RE: Allaso Vineyards Apartments
8901 Holly Avenue NE
Permanent CO – Not Accepted
Engineer's Certification Date: 09/17/2024
Engineer's Stamp Date: 11/19/21
Hydrology File: C20D086

Based upon the information provided in your submittal received 9/13/2024, and the site visit on 9/17/2024 the project is not approved for Permanent CO.

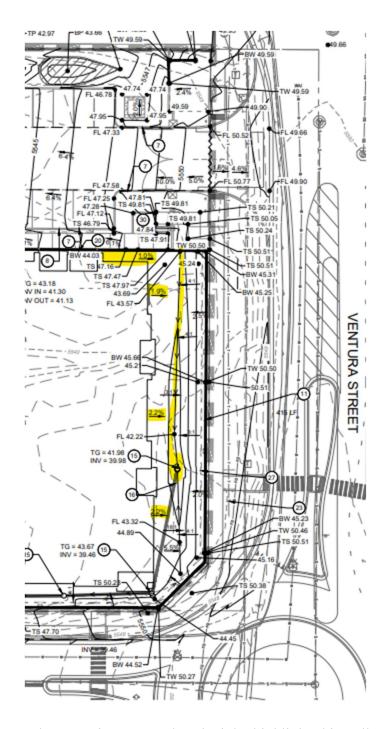
1. C-102: The area to the east of the building, and the area along the NE corner is of concern regarding possible flooding to the adjacent apartments. There does not appear to be a slope away from the building into a swale that directs the storm water to the drop grate (see areas in yellow showing where the slope needs to be looked at. The area where the swale is supposed to be located appears to be flat and not sloped according to the cross sections shown on C-104. Also of concern is the elevation of the drop grate. Please check and verify that the As-built elevation is low enough to capture the storm water intended to prevent flooding of the nearby apartments. From the field, it appeared that the elevation might be at the same or higher elevation than the finished floor.

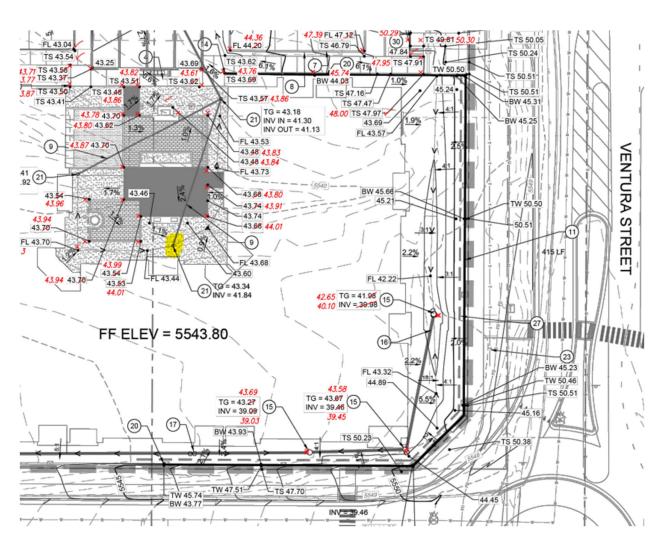
2. Inlet cover in courtyard – The inlet highlighted in yellow appeared to be too high to capture the storm water for this area. Please check and verify that the As-built elevation is low enough to capture the storm water intended to prevent flooding of the nearby apartments.
